Declaration for the Record of Decision Amendment

Environmental Conservation and Chemical Corporation, Zionsville, Indiana

Record of Decision Amendment Environmental Conservation and Chemical Corporation

ENVIRONMENTAL CONSERVATION AND CHEMICAL CORPORATION DIFFERENCES BETWEEN 1987 REMEDY AND REMEDY, AS MODIFIED

Figure 1

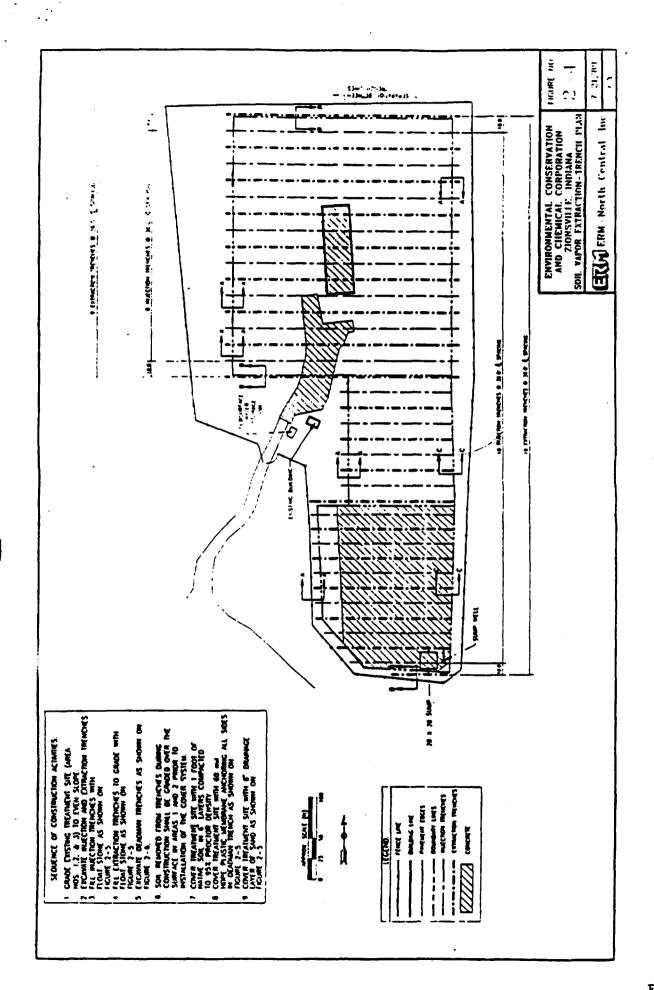
- The use of soil vapor extraction technology is selected in this Amendment, instead of the ground water collection and onsite treatment selected in the 1987 ROD.
- The ground water collection and treatment selected in the 1987 ROD would have resulted in cleanup of the site after a long period of system operation, whereas the soil vapor extraction selected in this Amendment will result in cleanup of the site in a significantly shorter period of time.

Figure 1 shows some components of the remedial action selected in this ROD Amendment.
